TECHNICAL BULLETIN

ZF Automatic Transmission – Noise in Reverse After Cold Start in Cold Weather – Repair Procedure

44-25

DATE 3/95

ILLUSTRATION 1

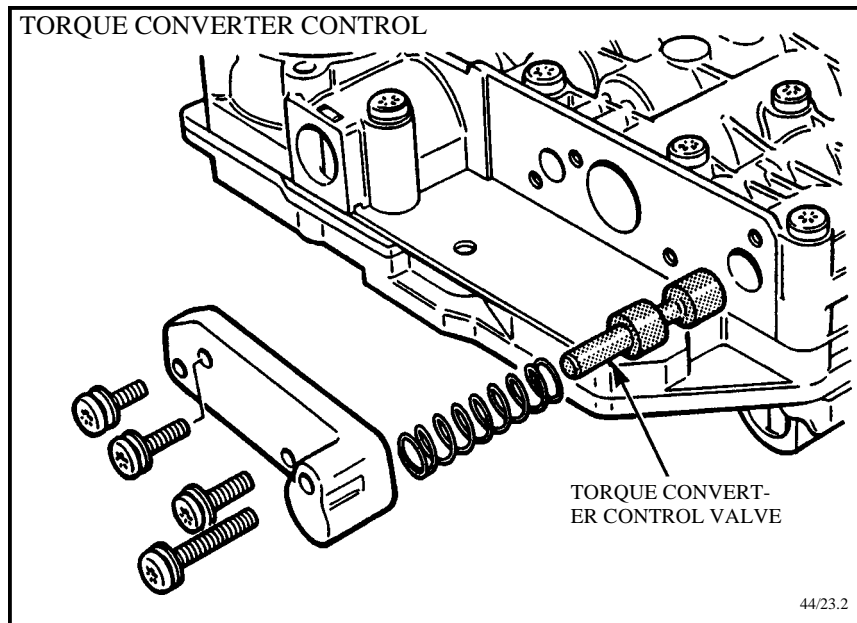
5. Remove the 4 screws shown in Illustration 1. Replace the existing torque converter control valve with a new control valve (part number NHD 5602AA).

6. Remove the 4 screws shown in Illustration 1 above. Replace the existing torque converter control valve with a new control valve (part number NHD 5602AA).

6. Reassemble the transmission. Torque the 13 valve body to transmission screws to 6 lb ft (8 Nm).
7. Drive the vehicle until it is at normal operating temperature (10 to 15 miles minimum). Immediately check the HOT transmission fluid level with the engine idling and the transmission in PARK.
Set the transmission fluid level to the MAX HOT mark on the dipstick.
8. Check the transmission for leaks.
